**RESOLUTION SETTING HEARING ON REQUEST FROM HUBBELL REALTY COMPANY FOR
THE 10TH AMENDMENT TO THE RIVERWOODS LEGACY PUD CONCEPTUAL PLAN FOR
PROPERTY LOCATED IN THE VICINITY OF RIVERWOODS ROAD AND RIVER RIDGE AVENUE**

**ZON2021-00028 (Vicinity of Riverwoods Road & River Ridge Avenue, Riverwoods PUD
Conceptual Plan Amendment)**

PRELIMINARY CONCEPTUAL PLAN FOR RIVERWOODS AMENDMENT # 10

RIVERWOODS CONCEPTUAL PLAN

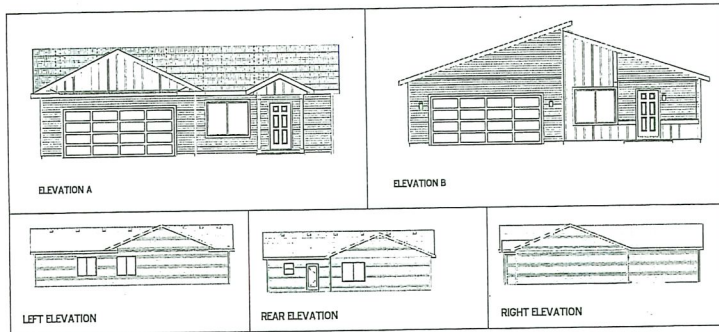
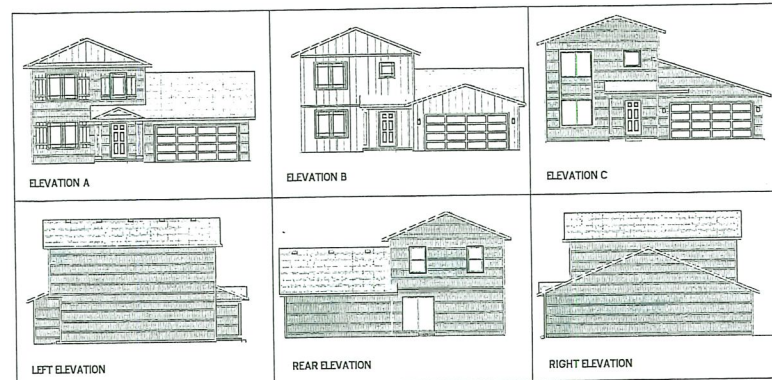
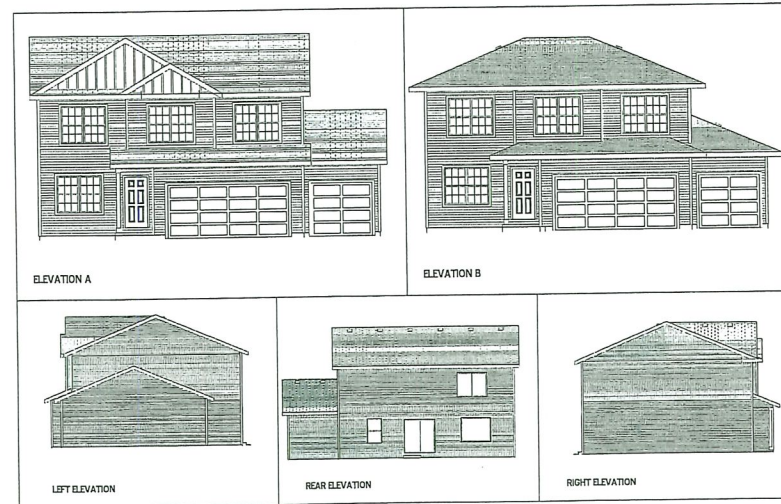
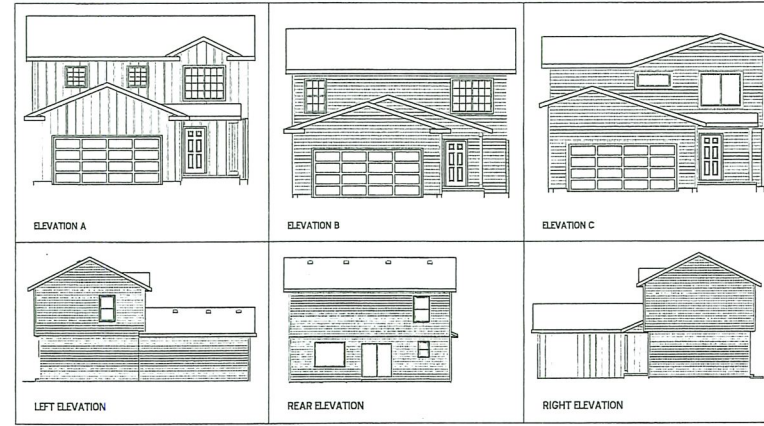
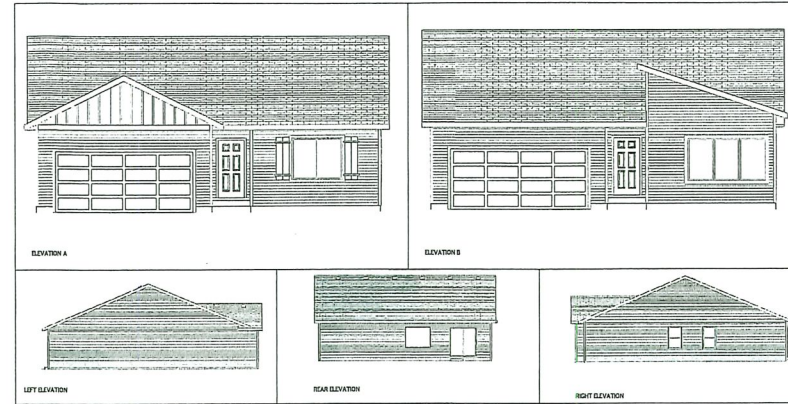
- a) No same house architectural elevation shall be built on adjacent lots.
 - b) Any house shall have a minimum two-car attached garage.
 - c) Any house constructed shall generally match one of the PUD House Character Elevations, including illustrative trim and siding mixes. Material upgrades and alternative house design may be approved by the Planning and Urban Design Administrator.

- d) The roof on any house constructed shall be of asphalt type shingles or cedar shakes. Standard 3-tab shingles are prohibited.
 - e) Any house shall be constructed with a minimum of 1,200 square feet of area.

- f) Exterior material for any house constructed shall be masonry (brick or stone), vinyl of no less than 0.042 thickness, cedar, LP Smart Siding, or fiber cement board. (ZON2021-00028)

RIVERWOODS MASTER PLAN

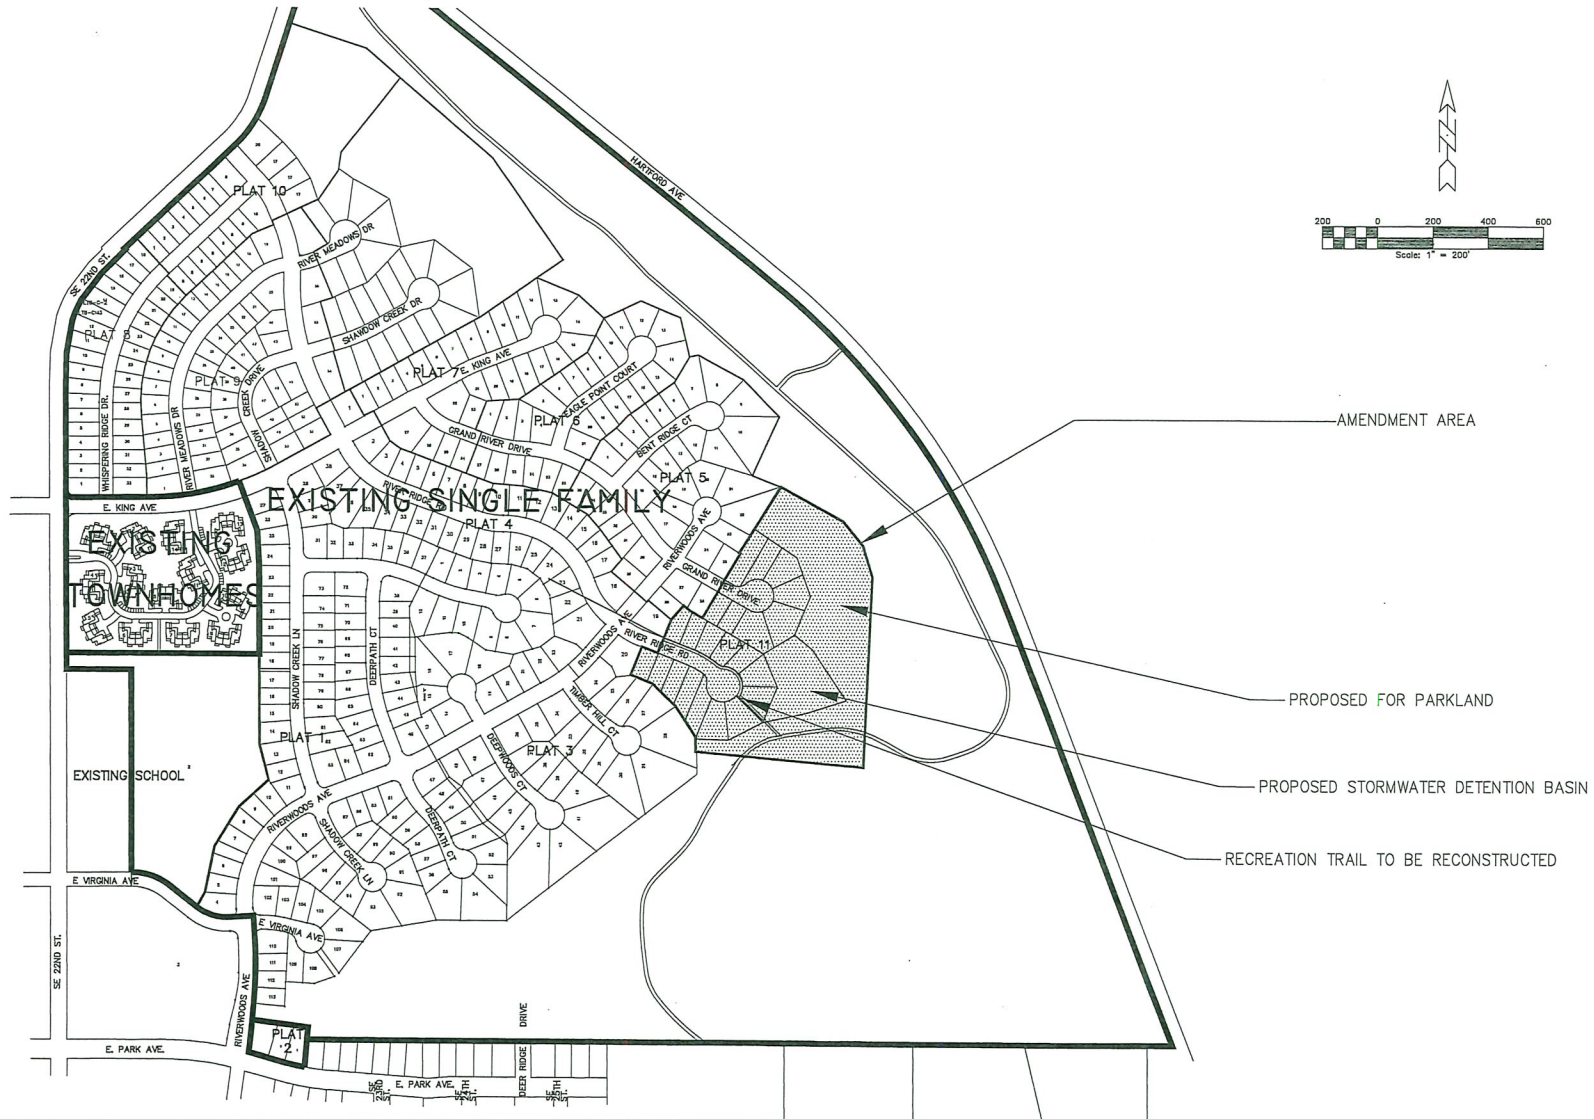
1. Provision of a note that states development of the site must comply with the Tree Removal and Mitigation Ordinance contained in Chapter 42, Article X, of the City Code.

2. Provision of a note to state that any and all portions of this area designated as "Parkland" that the City is not willing to accept ownership for, shall be designated as common areas shared by the owners of all the residential units. Common areas within a horizontal property regime are not separately taxed. In a horizontal property regime, the value of the common areas is allocated among the residential units.

3. Provision of a note that states the City will require the future plat to be located within a horizontal property regime, with the detention basins and open space areas designated as common areas shared by the owners of all the residential units. Common areas within a horizontal property regime are not separately taxed. In a horizontal property regime, the value of the common areas is allocated among the residential units.

4. Provision of a note that states any stormwater basin shall be designed to the satisfaction of the both the City's Engineering Department Director and the City's Park & Recreation Department Director to ensure that it is designed in a manner that prevents future erosion issues that could potentially impact the recreational trail.

5. Provision of a note that states that a soils report and stormwater runoff control plan per City Code Section 106-136 is required and that all grading is subject to an approved grading permit and soil erosion control plan.

6. Provision of a state note stating that permanent trail easements shall be provided for the Carl Voss Trail and for the trail spur providing access to the Carl Voss Trail from River Ridge Road, where these easements ensure that the trail shall not be moved or impacted by the developer.

7. Provision of a note stating the primary section of the Carl Voss Trail passing through the Riverwoods PUD shall not be altered by the amendment and shall not be closed at any time as a result of construction or development in the vicinity.

8. Provision of a note stating that the reconfigured trail spur providing access to the Carl Voss Trail from the bulb of the River Ridge Road cul-de-sac shall be designed and constructed to the City's standards as reviewed and approved by the City's Park & Recreation Department Director.

9. Provision of a note stating that the developer shall be responsible for all construction and costs associated with removing and reconstructing the trail spur providing access to the Carl Voss Trail from the bulb of the River Ridge Road cul-de-sac, and that any construction shall be to the City's standards for trail construction to the satisfaction of the City's Park & Recreation Department Director.

10. Provision of a note stating that the developer shall work with the City's Park & Recreation Director on an acceptable temporary closure of the trail spur providing access to the Carl Voss Trail from the bulb of the River Ridge Road cul-de-sac,

where the temporary closure is limited to as minimal of time as possible, and where the developer shall be responsible for neighborhood outreach and for provision of and maintenance of trail detour signage during any temporary closure to the satisfaction of the City's Park & Recreation Department Director. In addition, this temporary closure requires a 2-week notice, with detour signage in place at the start of the 2-week notice period.

11. Provision of an 8-foot wide sidewalk along one side of the River Ridge Road cul-de-sac to connect Riverwoods Avenue to the trail spur.
12. Provision of the following notes on the "PUD" Conceptual Plan:
